Product Change Notification

Date Issued :	July 18, 2024	PCN Number :	515405
Reason for Change :	Capacity change or tool replacement		
Description of Change :	This notification is to inform you about set of tooling is being added to meet the current and future demands of this product referenced below. There will be no changes in fit, form or function from additional tooling when compared to the existing tooling		
Reason for Short Notice :	Capacity Increase		
Assessment of Change :	First Article Inspection		
Planned Implementation Date :	July 30, 2024		
Customer Sample Availability Date:	July 15, 2024		
Last date to request Samples by Customer :	July 22, 2024

218910-1115

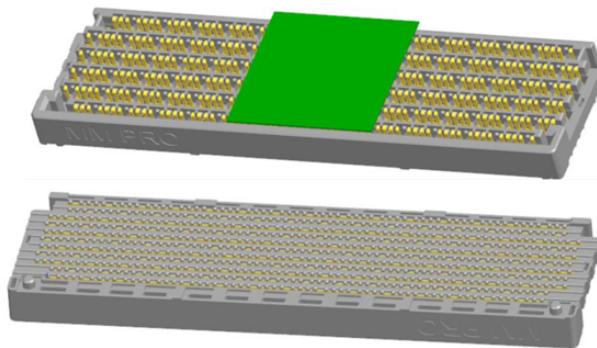
- This change is to expand the mold cavity to make the capacity increased to support the increasing demand of Mirror mezz 218910 series. we will qualify mold cavity expansion to make sure the parts can meet the Spec./requirements.
- Product Impact
 - No impact to fit, form or function.
- Part Number Impact
 - 218910-1115.
